POST OFFICE ENGINEERING DEPT
E-IN-C's OFFICE S BRANCH

FILE 5811/8 SPEC. D1475

SHELF
Nos. 1 & 2

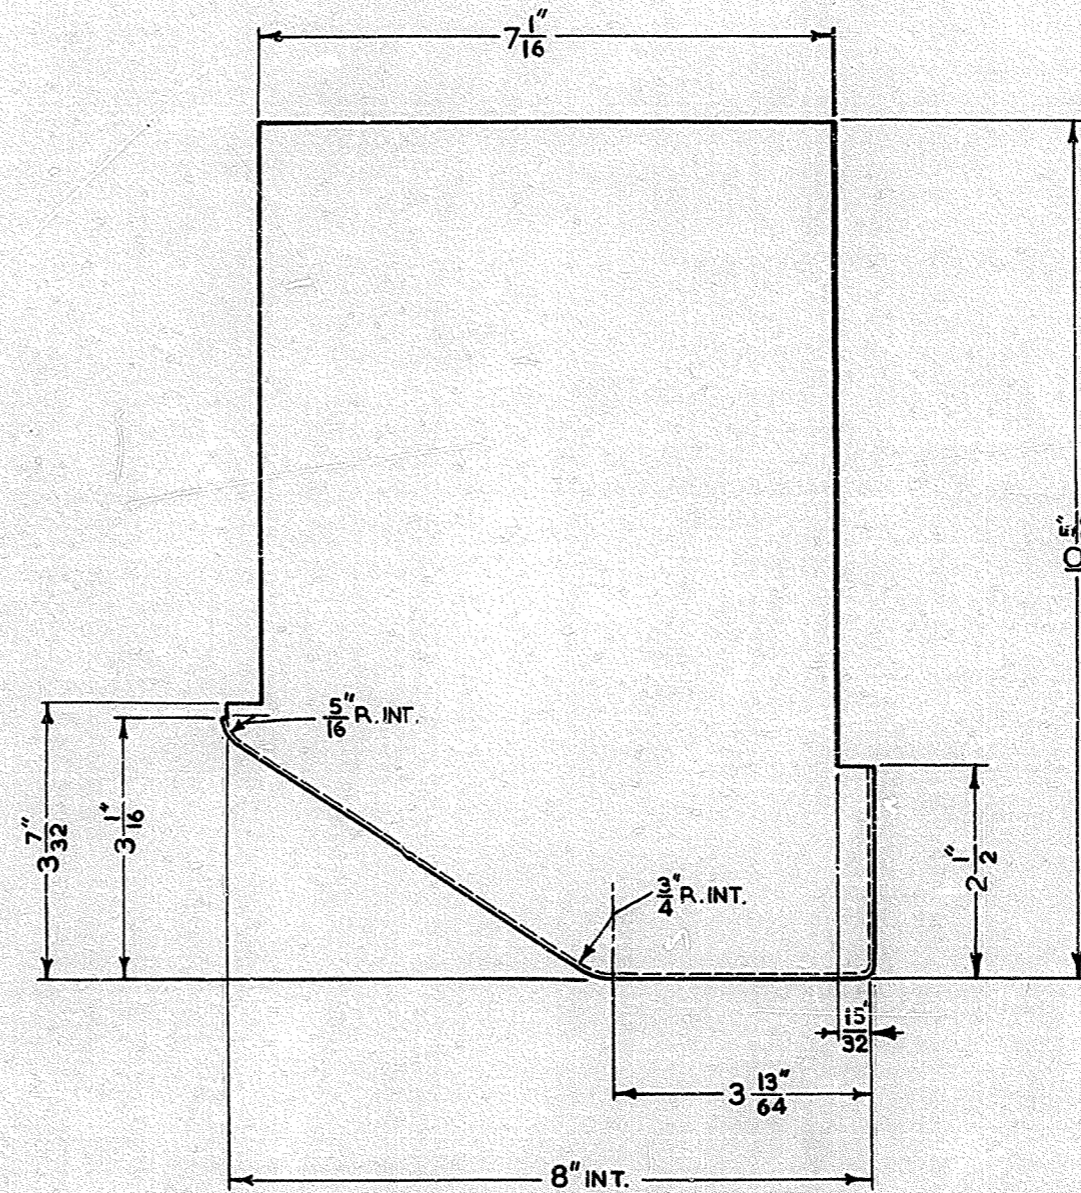
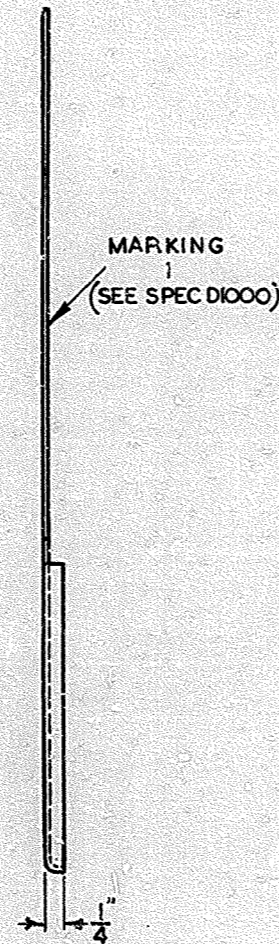
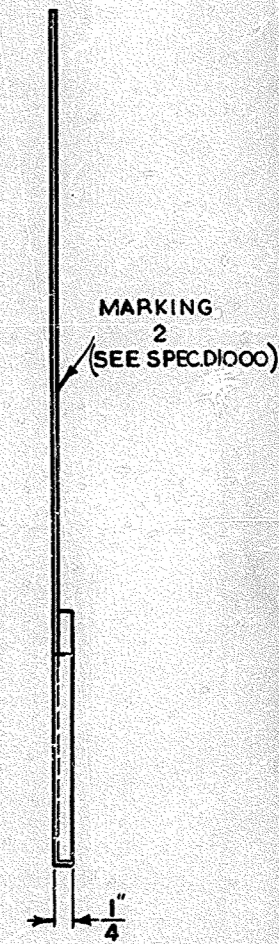
SHELF No. 1. DIM. 10 1/4" WAS 9 61/64" " 6 1/2" " 6 1/4" " 6 3/16" " 6 9/16" " 3/8" " 1/8"

SHELF No. 2. DIM. 10 1/4" WAS 9 61/64" " 6 19/16" " 6 1/16" " 7" " 6 3/4" " 3/8" " 1/8"

FLANGE ON REAR END OF EACH SHELF DELETED. 31-7-53 W.C.P. G.A.C. H.G.S. J.W.C.

REDRAWN. SHELF Nos. 1 & 2 REDIMENSIONED. DIM. 1/4 WAS 3/8. SHELF No. 2, ANGLE CORRECTED. 5. 10. 56.
